Elevating and Amusement Devices Safety Program	Ref. No.: 301 / 23
DIRECTOR'S SAFETY ORDER	Date: April 30, 2023

Re: Dover Counterweight Frame Cracks and Repair

INSTALLATION INSTRUCTIONS DOVER CWT REINFORCEMENT

Document No.: T17752-011, Rev -

“U” Type Crosshead (top beam)

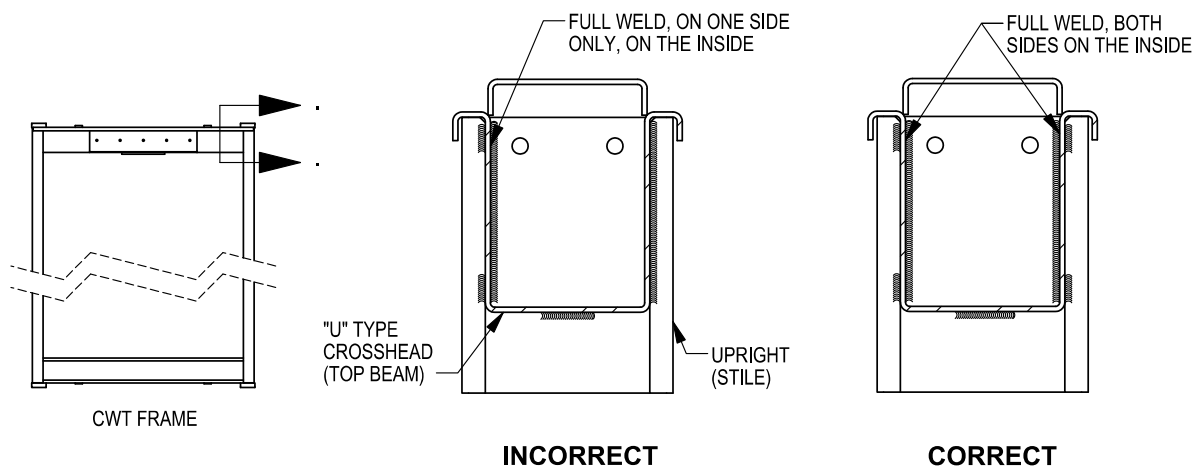
We recently found that some Dover-Turnbull Canada counterweight frames have developed cracks on the uprights (stiles) near the top weld with the crosshead. This is due high stresses developed in the cracked region because of asymmetrical welds between the crosshead and the upright.

When welded properly, the crosshead is welded to the upright by a full weld on each side on the inside of the crosshead web, and two intermittent (1in long) on the outside. The improperly welded crosshead will have only one side the crosshead web welded on the inside.

If the crosshead is welded incorrectly, it needs to be reinforced to prevent high stresses.

Inspect and apply retrofit if required.

Counterweight Frame

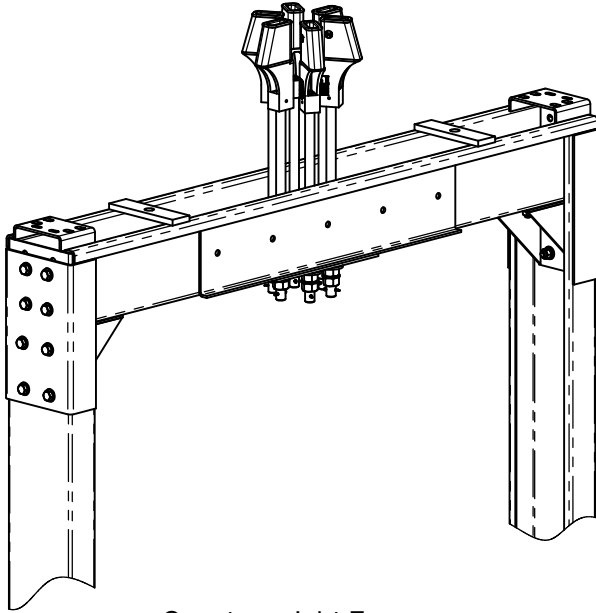
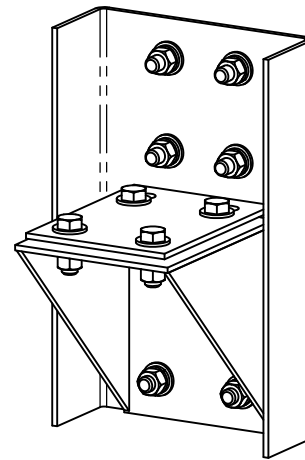
Install a reinforcement bracket kit #T17752-120 at the top corners of the CWT frame.

Reinforcement bracket.
See Kit #T17752-120

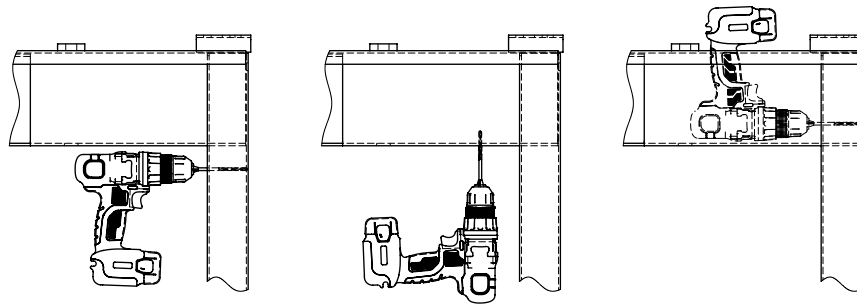
- 3.1. Without removing guiding means, use the angle-bracket as template and the drilling template provided to mark up the location of the holes to be drilled.

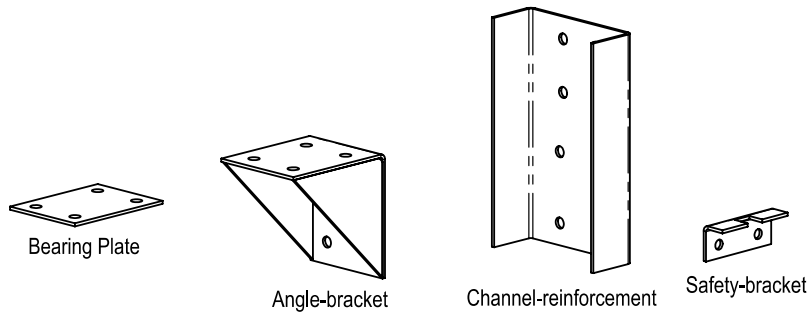
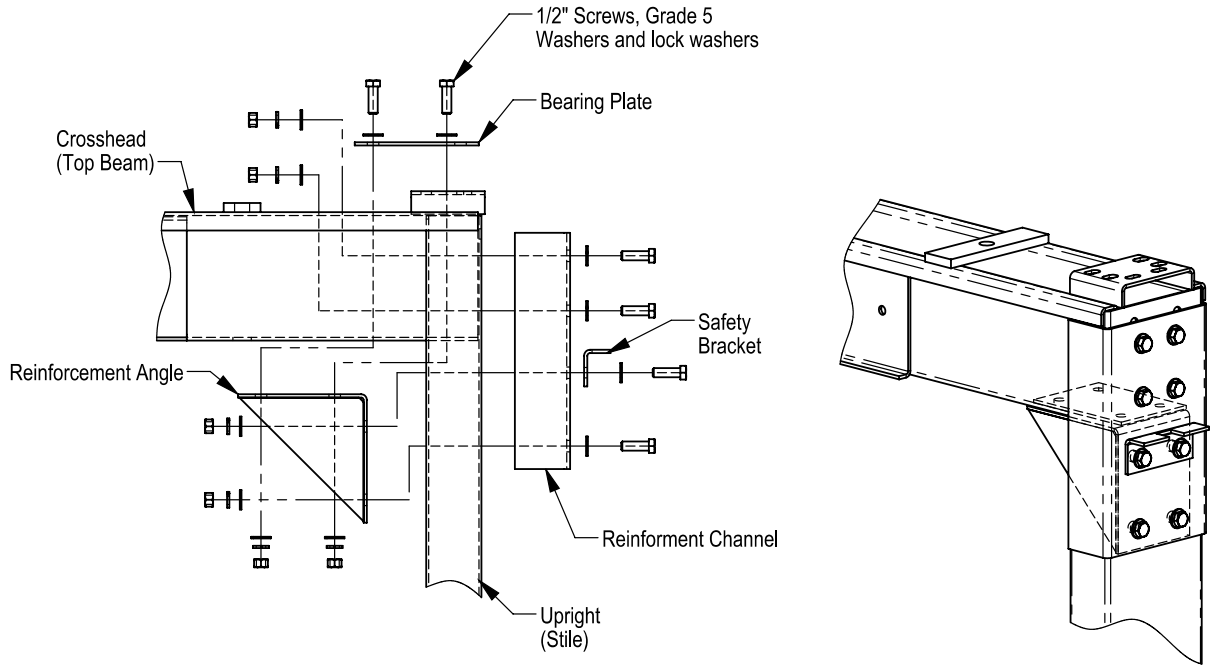
3.2. Drill 12X Ø9/16" (0.562") holes on the marked-up locations.

3.1. Install the Angle-Bracket, Channel-Reinforcement, Bearing-plate, and safety bracket as shown.
